<b>Title - Sujet</b> Elec., Communication & Elec. Safety	
<b>Solicitation No. - N° de l'invitation</b> 21C82-120400/A	<b>Amendment No. - N° modif.</b> 002
<b>Client Reference No. - N° de référence du client</b> 21C82-120400	<b>Date</b> 2013-07-25
<b>GETS Reference No. - N° de référence de SEAG</b> PW-\$PWY-020-7035	
<b>File No. - N° de dossier</b> PWY-3-36036 (020)	<b>CCC No./N° CCC - FMS No./N° VME</b>
<b>Solicitation Closes - L'invitation prend fin</b> <b>at - à 02:00 PM</b> <b>on - le 2013-07-31</b>	<b>Time Zone</b> Fuseau horaire Pacific Daylight Saving Time PDT
<b>F.O.B. - F.A.B.</b> <b>Plant-Usine:</b> <input type="checkbox"/> <b>Destination:</b> <input checked="" type="checkbox"/> <b>Other-Autre:</b> <input type="checkbox"/>	
<b>Address Enquiries to: - Adresser toutes questions à:</b> Ly, Ronny(PWY)	<b>Buyer Id - Id de l'acheteur</b> pwy020
<b>Telephone No. - N° de téléphone</b> (604) 666-0043 ( )	<b>FAX No. - N° de FAX</b> (604) 775-6633

This Amendment 002 (Addendum No. 2) is raised to provide clarifications to the specifications and drawings and to answer questions from bidders. Please note the Electrical Addendum No. 1 was included in the original Specification package.

Proj. No. 052462.001	Scale: 1:100	Date: 13 July 23	Designed: K.B.	Drawing No.: ESK-E300-01
-------------------------	-----------------	---------------------	-------------------	-----------------------------

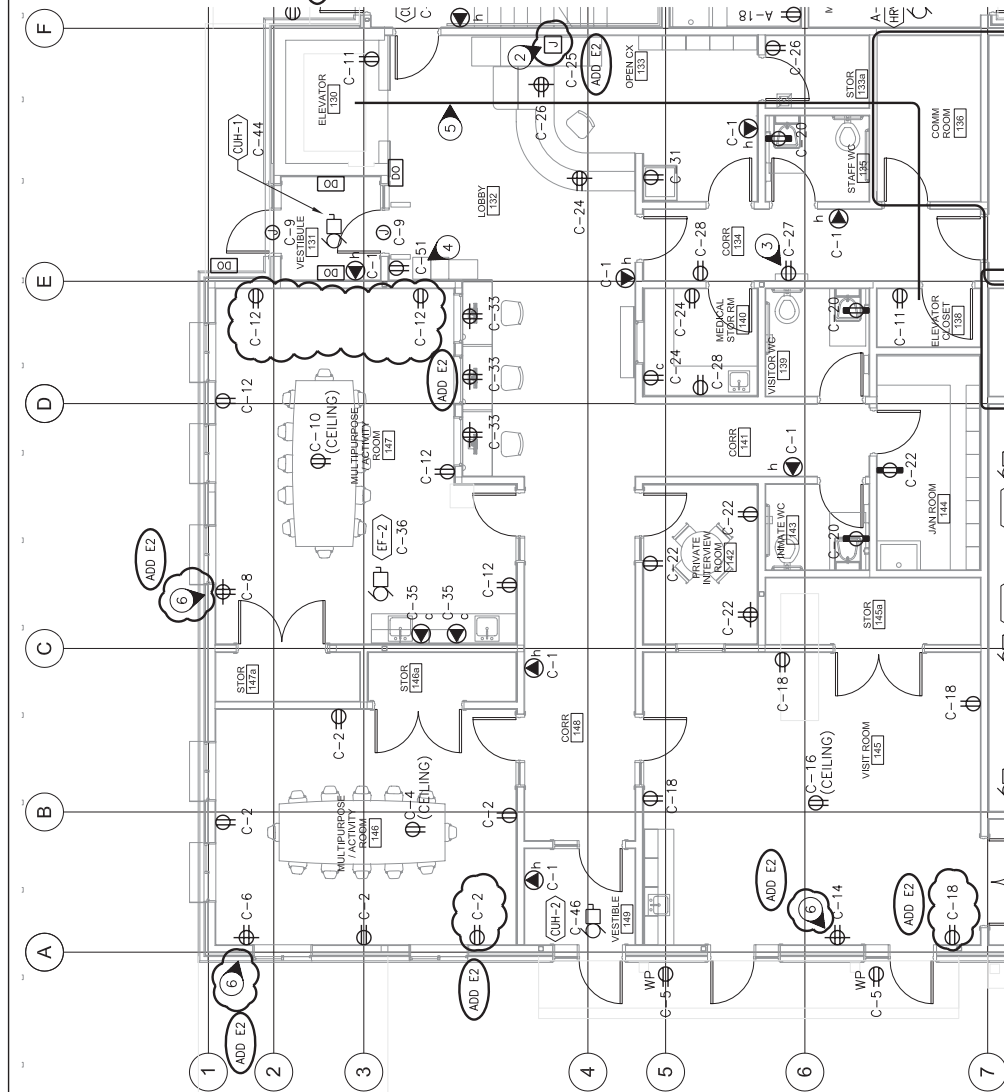
- .1 **Revise:** Refer to ESK-E300-01 for the revised receptacle layout in Visit Room 145, Multipurpose 146 and Multipurpose 147. Coordinate multimedia connection requirements in the rooms listed with the Departmental Representative.
- .2 **Revise:** Refer to ESK-E300-01 for the revised x-ray equipment connection requirements.
- .3 **Revise:** 'FFH-1' circuit number to read, "C-64, 66". Panel C, Circuit 42 space shall be equipped with a 15 A, single pole circuit breaker noted as spare. Updated panel schedule accordingly.

Proj. No. R.052462.001	Scale: 1:100	Date: 13 July 23	Designed: K.B.	Drawing No.: ESK-E400-01
---------------------------	-----------------	---------------------	-------------------	-----------------------------

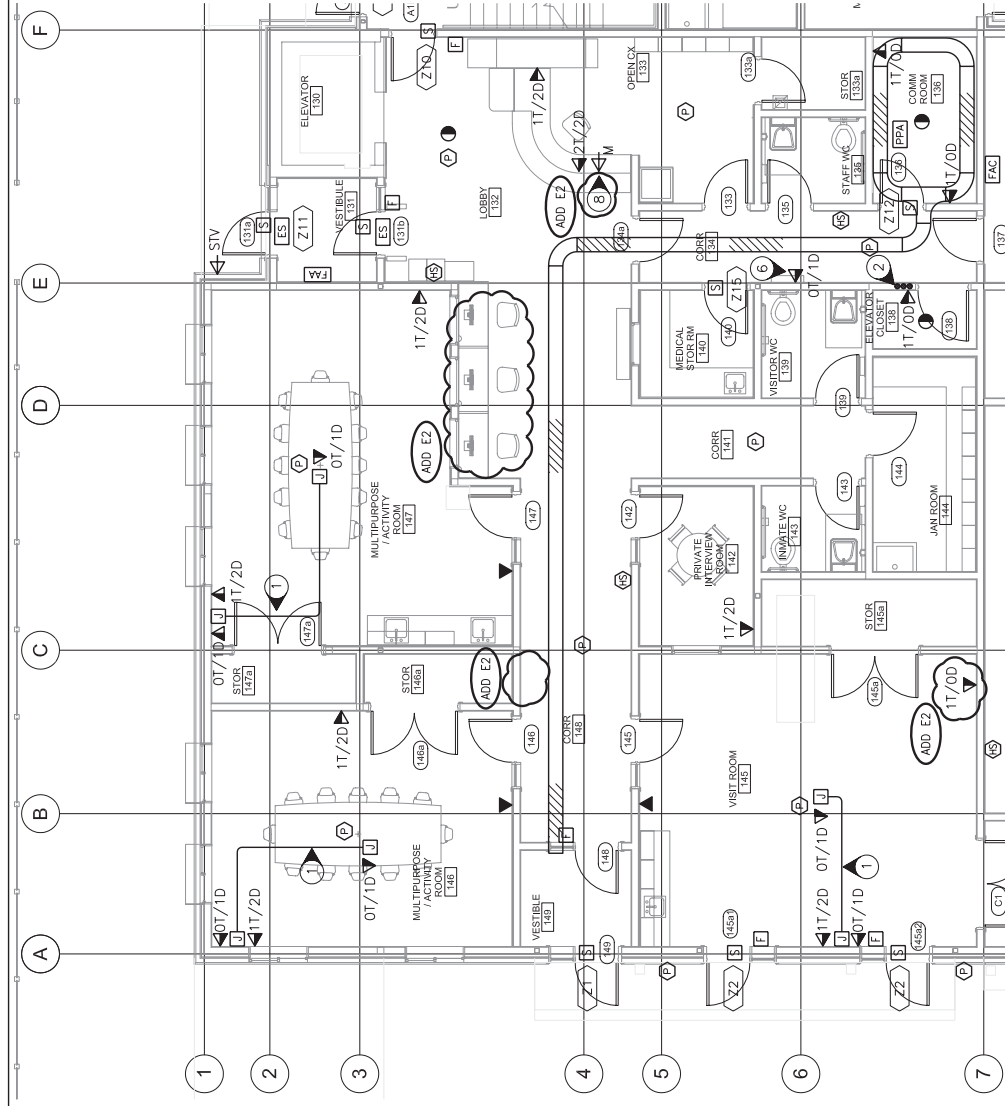
- .1 **Delete:** Inmate telephone in Corridor 148. See ESK-E400-01.
- .2 **Delete:** Computer workstation structured cabling outlets in Corridor 148. See ESK-E400-01.
- .3 **Revise:** Refer to ESK-E400-01 for the revised structured cabling drop count in Visit Room 145.

- .4 **Add:** Coordinate mounting and location of intercom station with the Departmental Representative. See ESK-E400-01.
